### REGULAR MEETING OF THE THIRD LAGUNA HILLS MUTUAL ARCHITECTURAL CONTROL AND STANDARDS COMMITTEE

Monday, October 28, 2019 – 9:30 a.m.
Laguna Woods Village Community Center Sycamore Room
24351 El Toro Road

#### STAFF REPORT

Request to Extend Entryway onto Exclusive Use Common Area and to Replace Planter with Concrete Slab on Previously Extended Common Area

#### Attachment:1

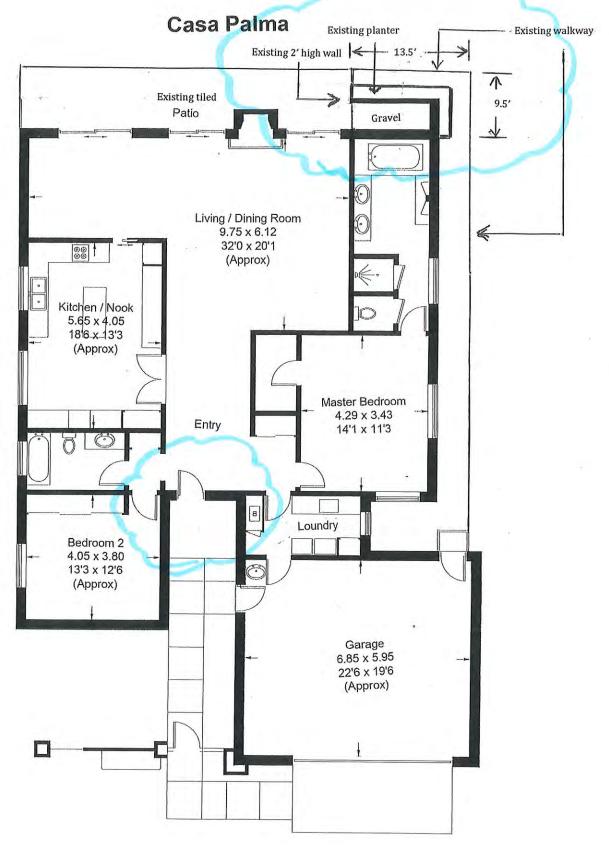
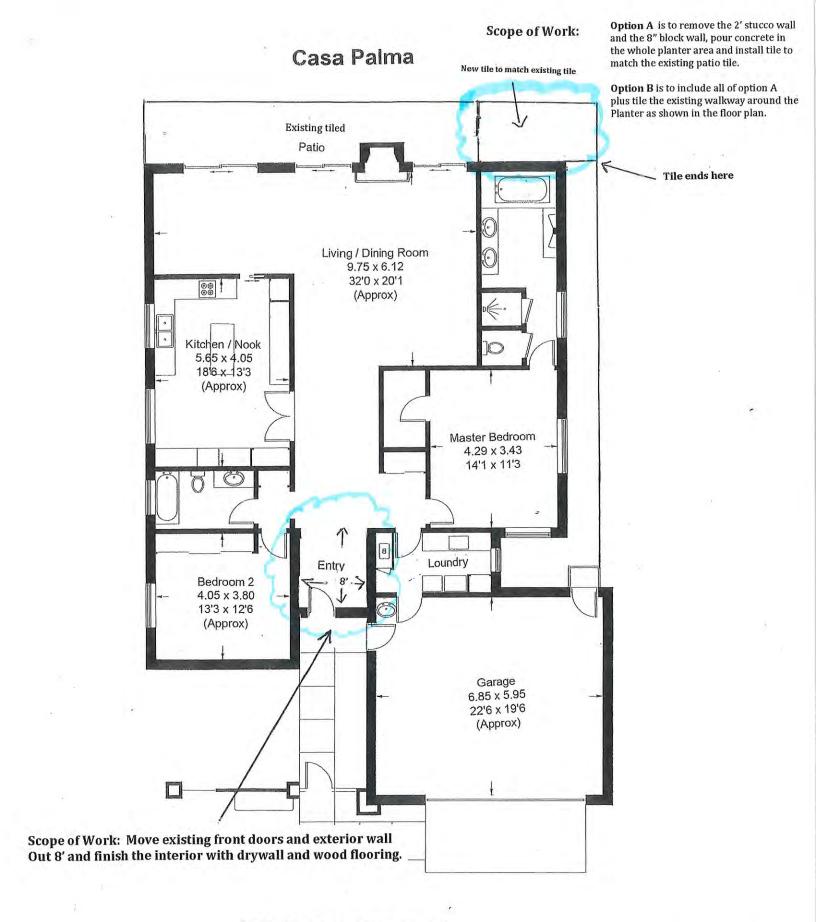
Mr. Ferraro of 5598-A Vista Del Mando, a Casa Palma style unit, is requesting Board approval of a variance to extend the existing entryway onto exclusive use common area by constructing a new wall and relocating the existing door 8' into the entry way (see Attachments 1 and 2).

Mr. Ferraro is proposing to move the existing 6'-0" wide by 8'-0" tall double entry doors forward by 8' to extend his entryway. This proposal would take place under the existing roof and would not require any new roof tie-in. The existing skylight will allow for natural light in the covered entryway. According to the condominium plan for the unit the entryway is exclusive use common area.

Staff recommends the Board approve the request to extend the entry way onto Exclusive Use Common Area with the conditions 2-28 stated in Appendix A, and deny the request to replace the planter with concrete slab. Should the Board approve the request to replace the planter with concrete, staff recommends it be with the additional condition #1 as stated in Appendix A.

# Attachment: 3

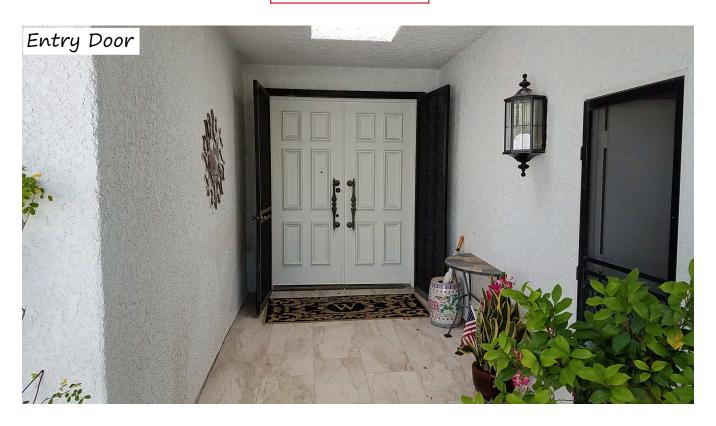
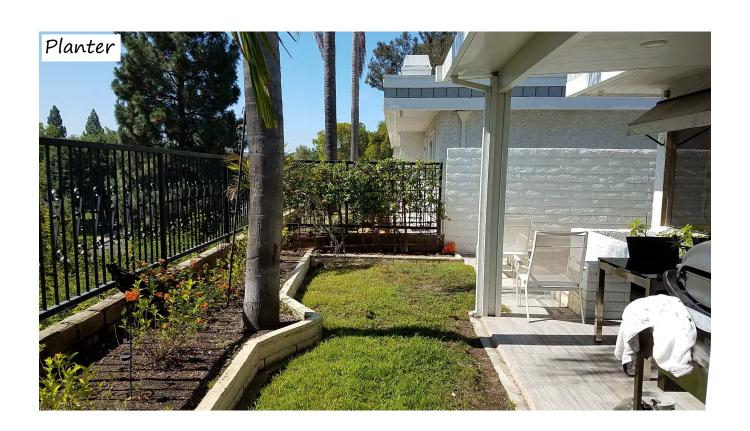
remove the existing original planter along with an alteration planter (installed with Mutual Consent in 2012) and to replace it with a concrete slab to allow for tiling the area to match the rest of the rear patio. The area is approx. 11'9" wide and 6-6" long located behind the master bathroom; see site plan for clarification (see Attachment 1). The proposed area is enclosed with a block wall with wrought iron fence (see Attachment 3) and has no direct access from other common area locations.

Staff recommends denial of this request in conjunction with current Third Mutual's Common Area Use Policy (RESOLUTION 03-18-146) "BE IT RESOLVED FURTHER, that no further alteration may be approved or constructed on any previously approved or "grandfathered" alteration that encroaches upon common area, other than like for like, that augments, enlarges, or changes the construction, purpose, or use of the previously approved or grandfathered alteration."
